KNOXVILLE UTILITIES BOARD

**Addendum No. 2**

Project: **Kuwahee WWTP Combined Heat and Power Facility**

Control No: **952**

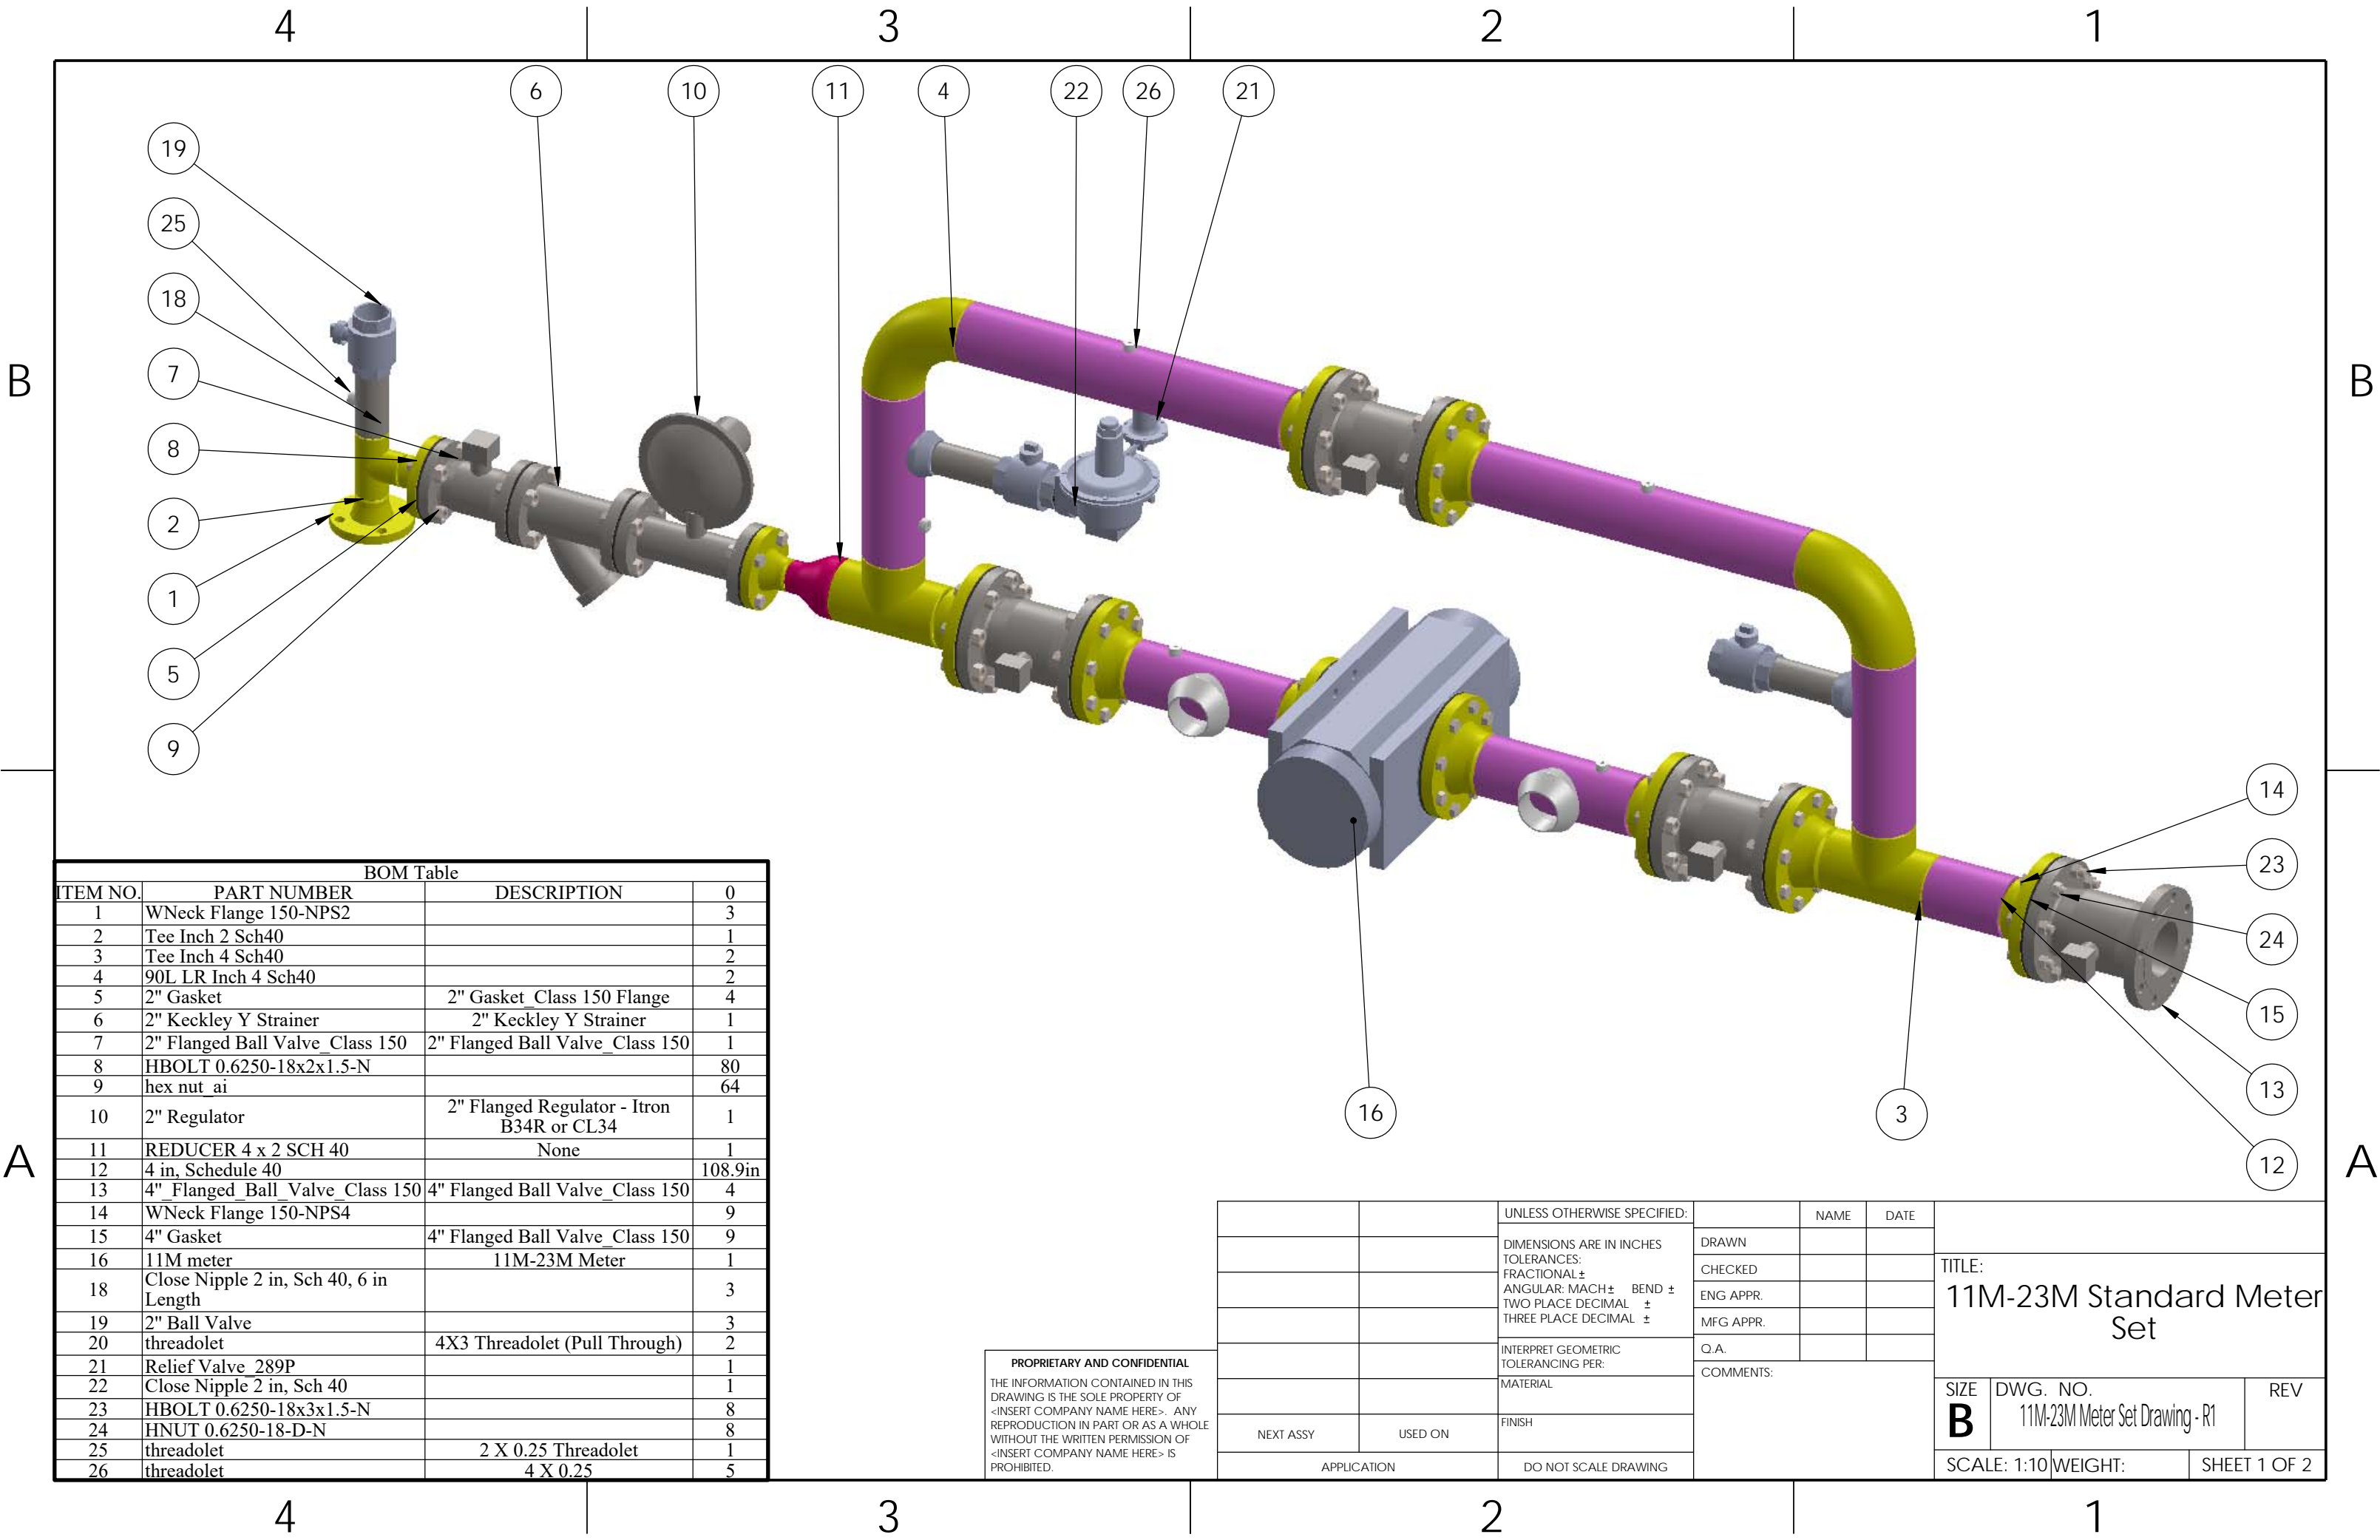
**Question 14:** Please provide information on the gas meters to be provided by KUB. Will the gas meters include pressure regulators?

**Answer 14:** The gas meters will include pressure regulators. Please refer to the attached drawing sheet for additional information on the gas meter.
